CITY OF COFFEYVILLE
BOARD OF COMMISSIONERS AGENDA ITEM

MEETING DATE	June 10th 2014	
RESOLUTION OR ORDINANCE NUMBER	R-14-46	
AGENDA TITLE	**Change order with Muller Construction Inc., for the intersections of 3rd and Central and 3rd and Spruce**	
REQUESTING DEPARTMENT	Engineering	
PRESENTER	Scott Massman, Superintendent of Engineering	
FISCAL INFORMATION	Cost as recommended:	$12,368.00 and $17,887.00
	Budget Line Item:	
	Balance Available	
	New Appropriation Required:	[X] Yes [] No
PURPOSE	Due to the very poor soil conditions at the above mentioned intersections and upon recommendations of Michael Atkinson, P.E. of Allgeier, Martin and Associates, Inc. our project engineer over-excavating 1 foot with placement of an additional 1 foot of rock as well. Mike explains the method proposed as follows: I just wanted to reiterate the difference with the Geogrid option that went for $37/SY versus the $16.20/SY that Muller is proposing. It was my understanding that the subgrade for 2nd & Central consisted of very poor material which was further compounded by very wet conditions. We considered the rock option, but due to the severity of the poor conditions, we felt it was necessary to use the

SITE PLAN
3RD STREET AND SPRUCE STREET INTERSECTION IMPROVEMENT
COFFEYVILLE, KANSAS

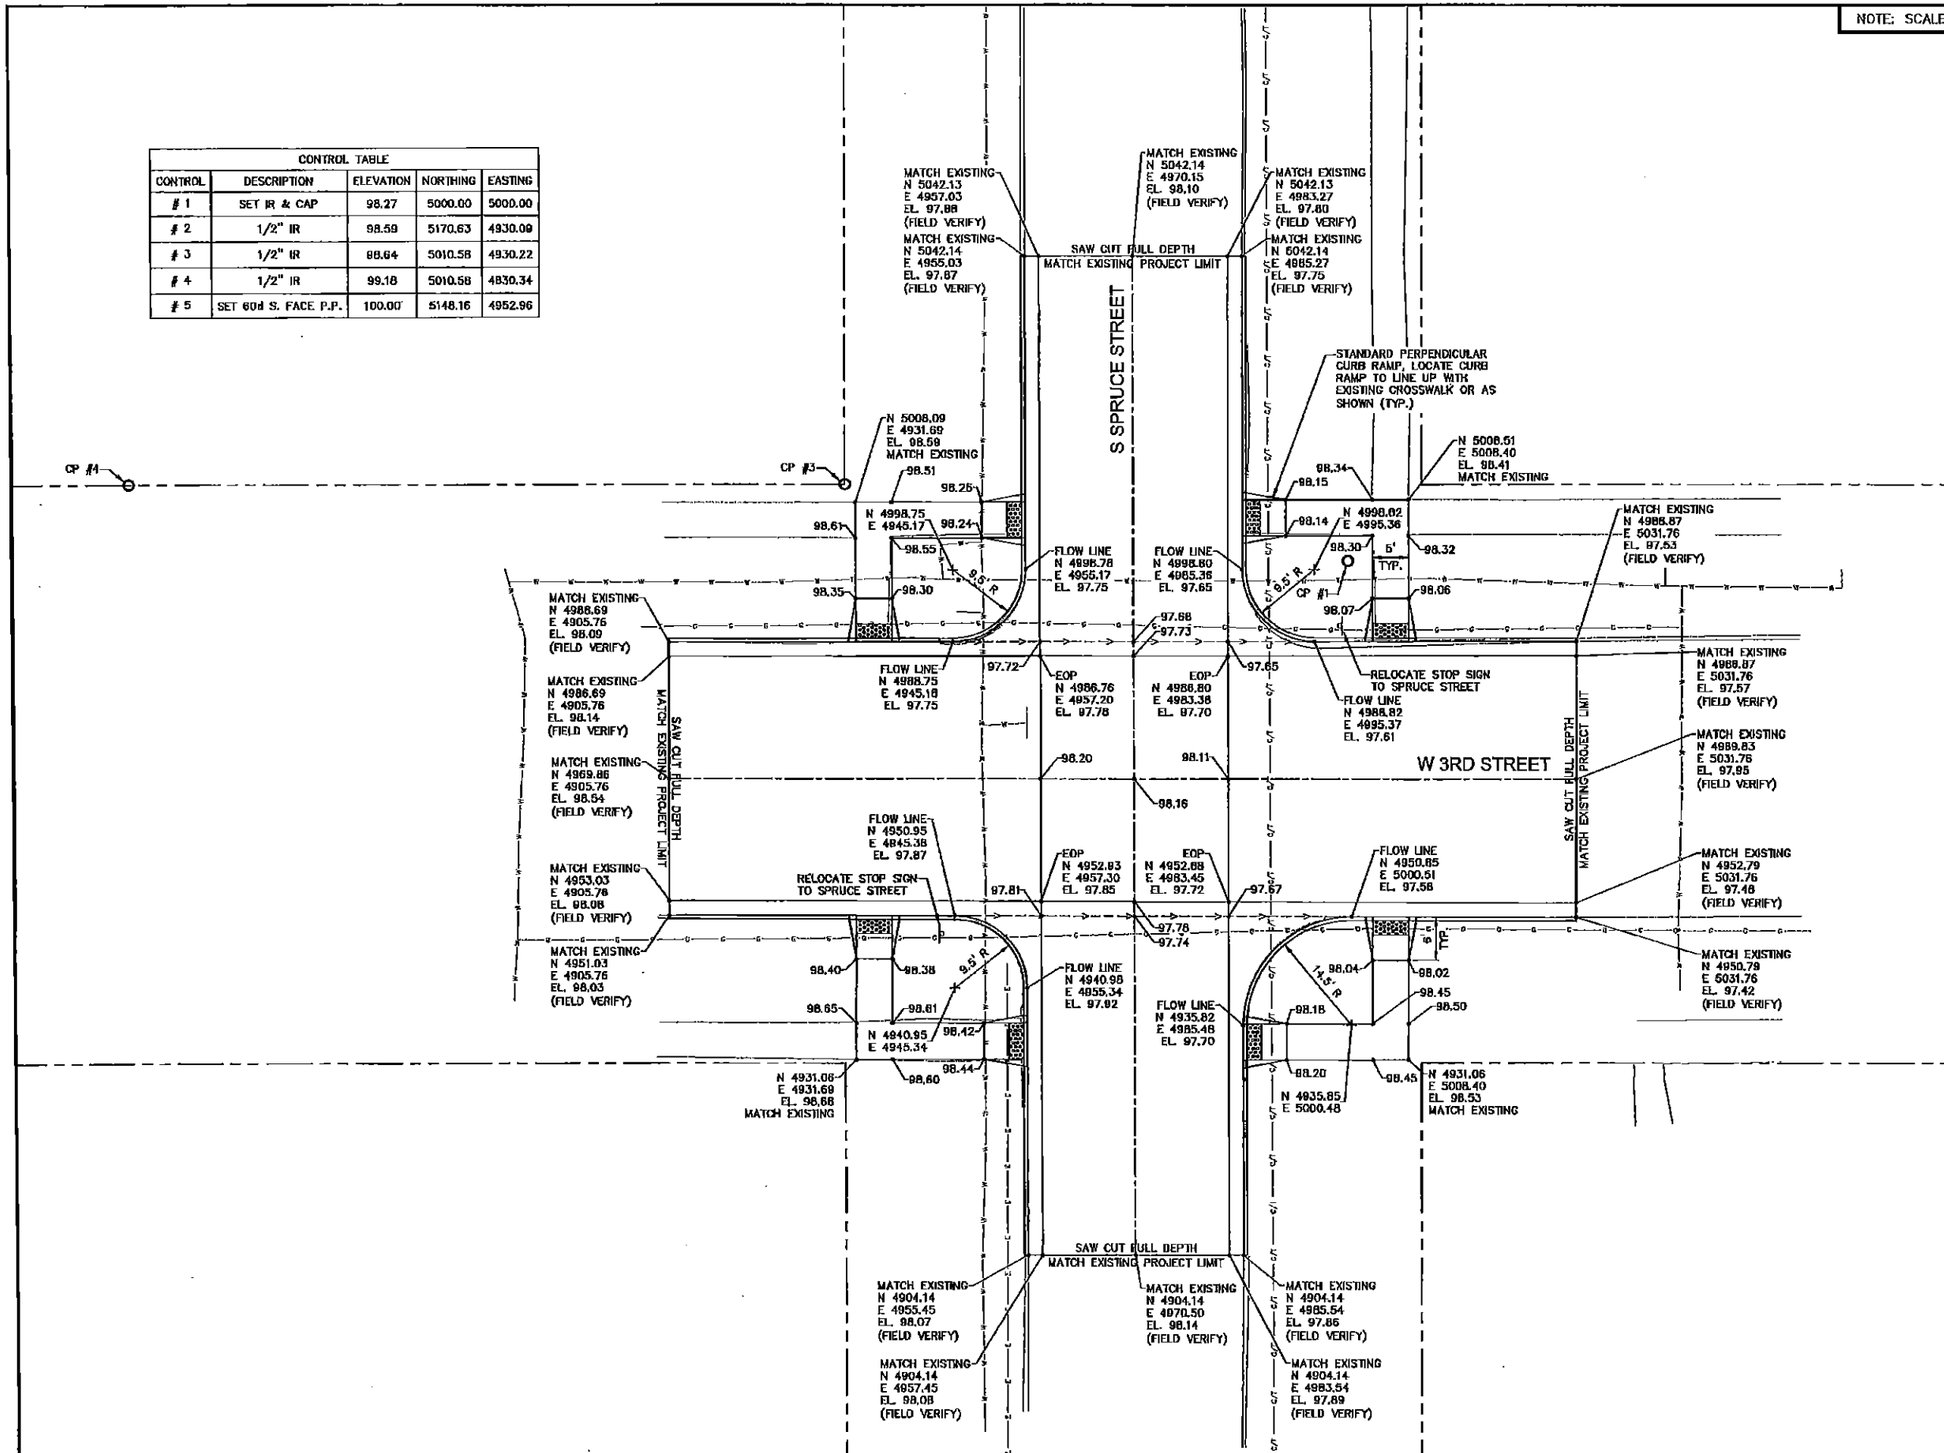
1) **3rd & Spruce Intersection (@ 1,104 SY)**
Over excavate 1 foot of unsuitable material and haul away.
Procure, haul, place and compact 1 foot of 6 x 0 inch crushed stone. **ADD**, Lump Sum $ 17,887.00

2) 3rd & Spruce Intersection @ 1104 S.Y.
Over-excavate 1 foot of unsuitable material and haul away. Procure, haul, place and compact 1 foot of 6 x 0 crushed stone.

SITE PLAN
3RD AND CENTRAL INTERSECTION IMPROVEMENT
COFFEYVILLE, KANSAS

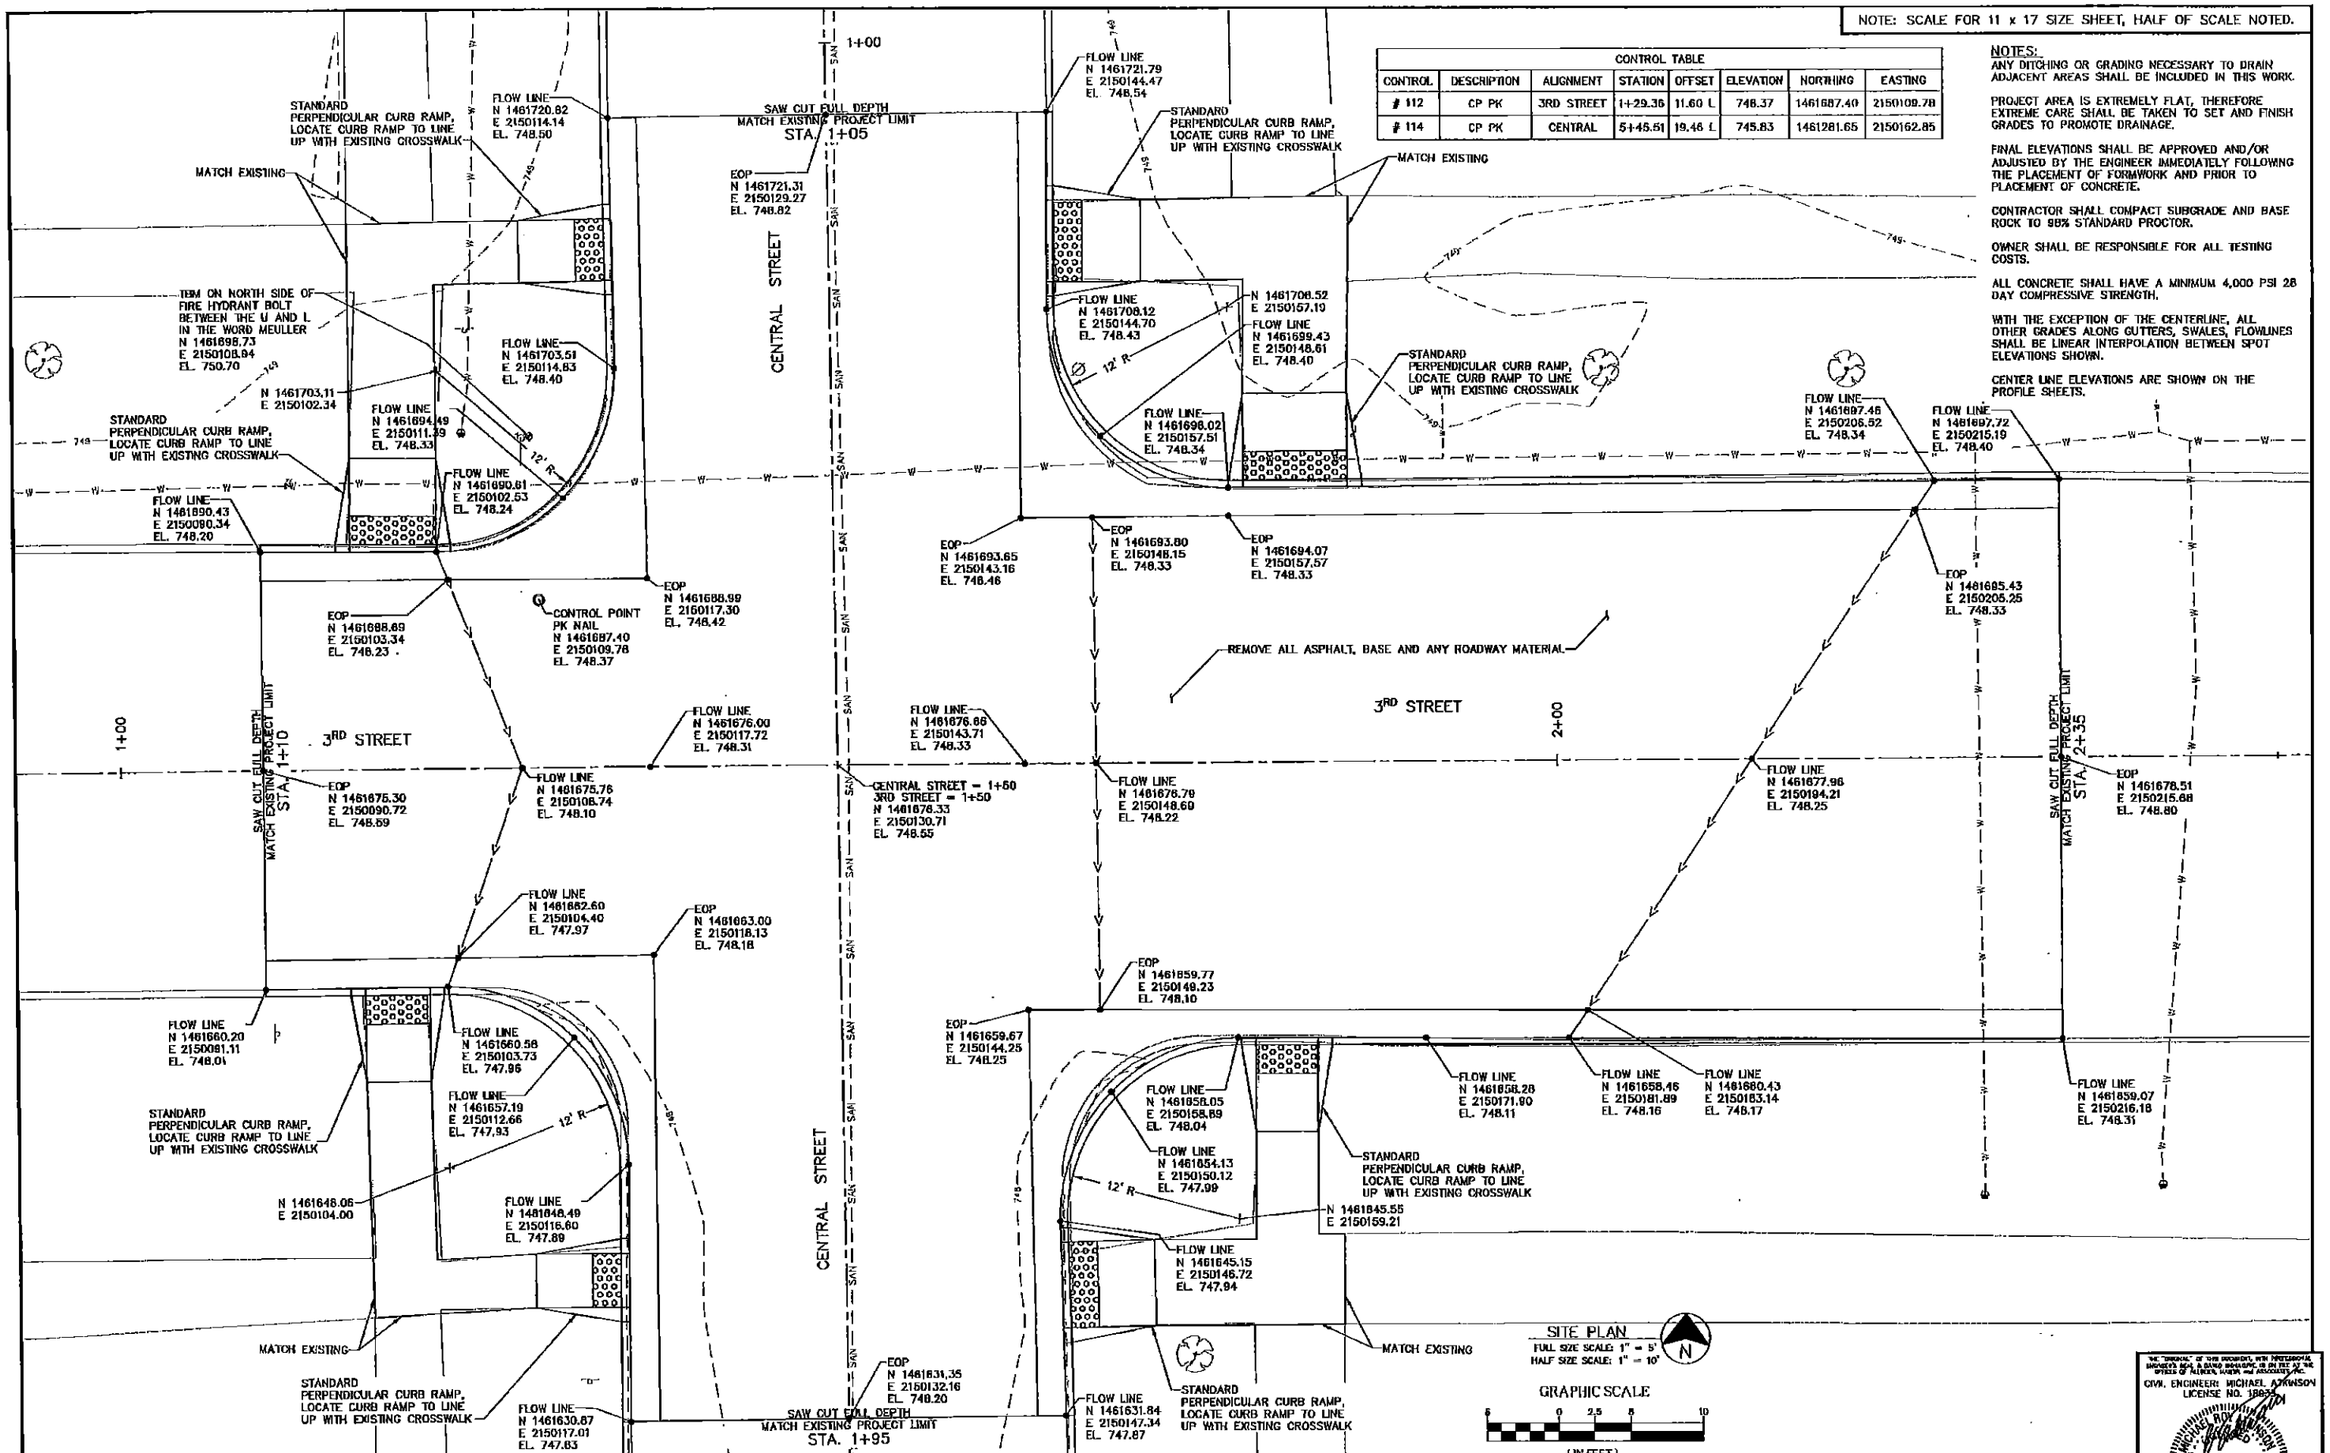
1) **3rd & Central Intersection (@ 764 SY)**
Over excavate 1 foot of unsuitable material and haul away.
Procure, haul, place and compact 1 foot of 6 x 0 inch crushed stone. **ADD**, Lump Sum $ 12,368.00

1) 3rd and Central Intersection @ 764 S.Y.
Over-excavate 1 foot of unsuitable material and haul away. Procure, haul, place and compact 1 foot of 6 x 0 crushed stone.
